## Question 2

(i) Questions on filters. What specifically will you change from ProtoDUNE I? How will these changes be validated?

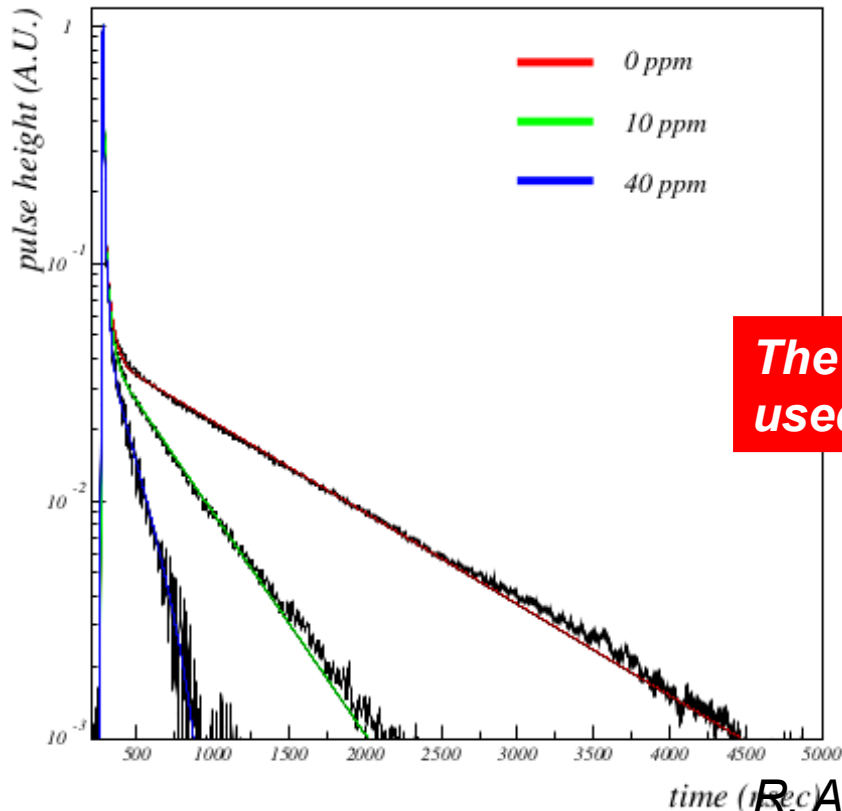
(i) Can you show how much light is lost from quenching, attenuation, filter, etc to show that they are consistent with simulations.

- The decay time of the triplet component of scintillation light depends on the Nitrogen contamination
- The absorption of scintillation photons is characterized by an absorption factor of  $(1.51 \pm 0.15) \times 10^{-4} \text{ cm}^{-1} \text{ ppm}^{-1}$ . Singlet and triplet components are affected in the same way.

**The value of the triplet lifetime is used to infer the  $N_2$  concentration**

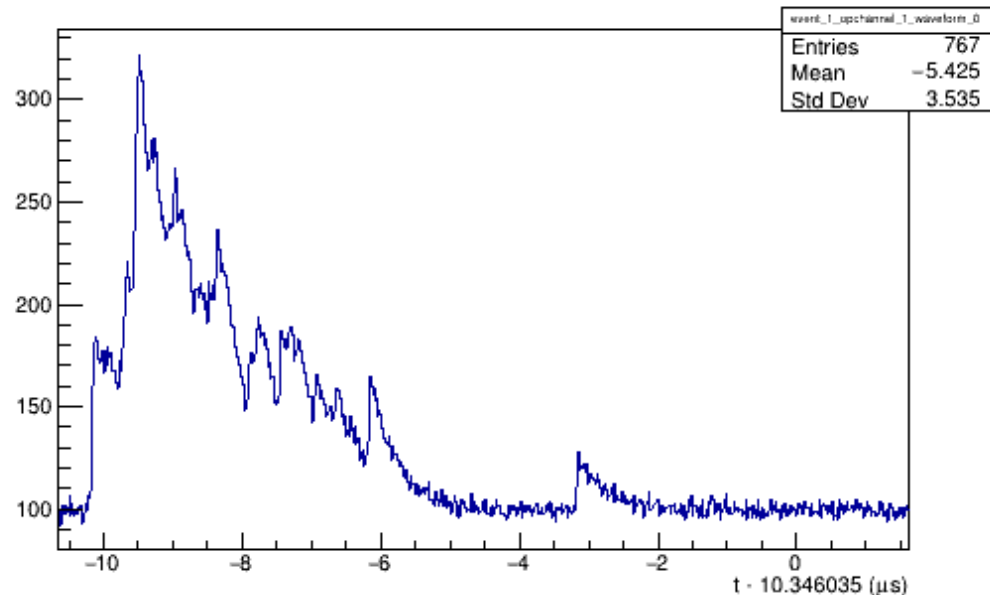
(i) Can you show how much light is lost from quenching, attenuation, filter, etc to show that they are consistent with simulations.

The scintillation photon yield of LAr depends on the ionizing particle type, on the linear energy transfer (LET), on the E field, and on quenching.

We have recently included in the LArSoft simulation the LY dependence on  $dE/dx$  and E field in the  $2 \text{ MeV/cm} < dE/dx < 40 \text{ MeV/cm}$  and  $0.25 \text{ kV/cm} < E < 0.5 \text{ kV/cm}$  range\*

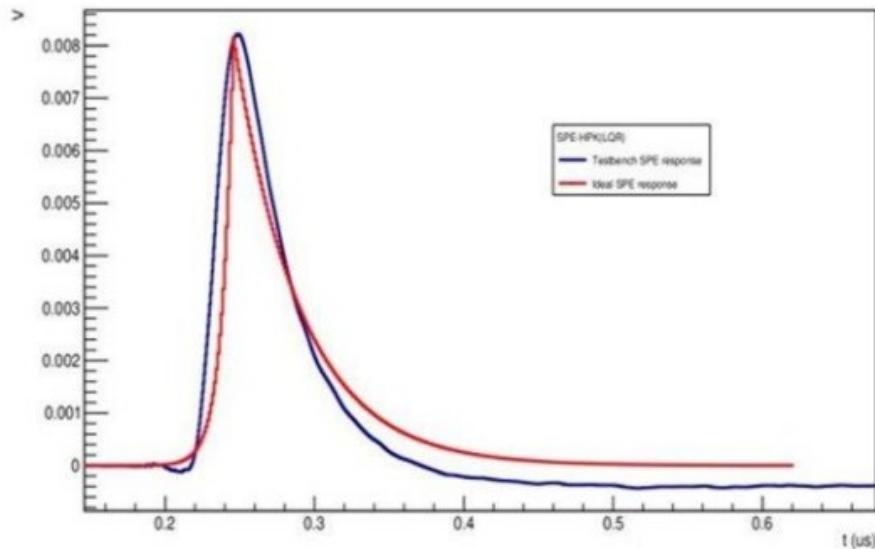
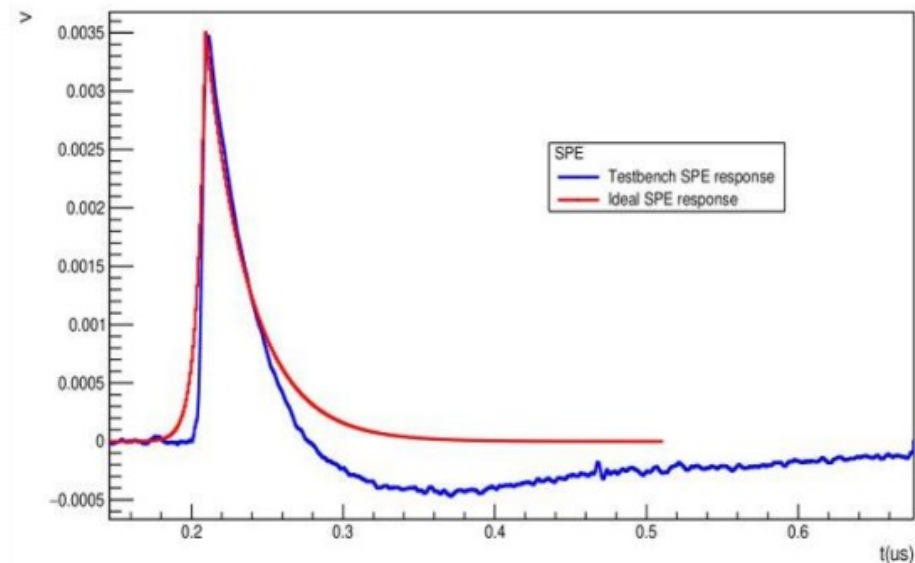
(ii) Show how electronics, firmware, etc are folded into the simulation. How were these validated?

Transitioning from an ideal single PE response to a test bench one

Average SPE template (HPK)

Average SPE template (FBK)

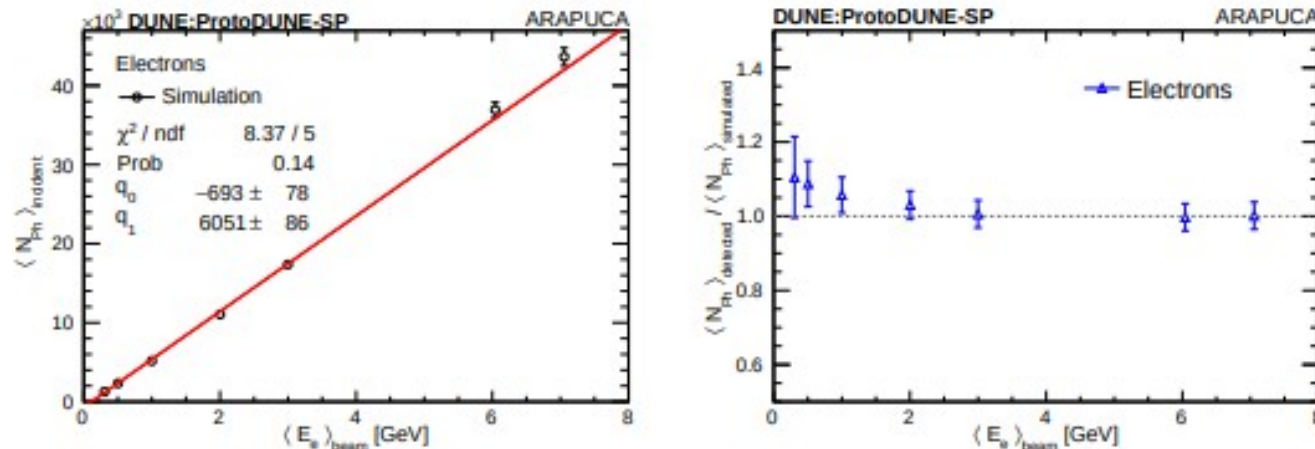
(iii) Was there a light yield measurement made in ProtoDUNE I? Is so, please give the results.

An indirect measurement was obtained using beam electron data: LY = 102.1 photons/GeV. The quoted LY is relative to a diffuse light source (EM shower) at a distance of about 3 m from the detectors
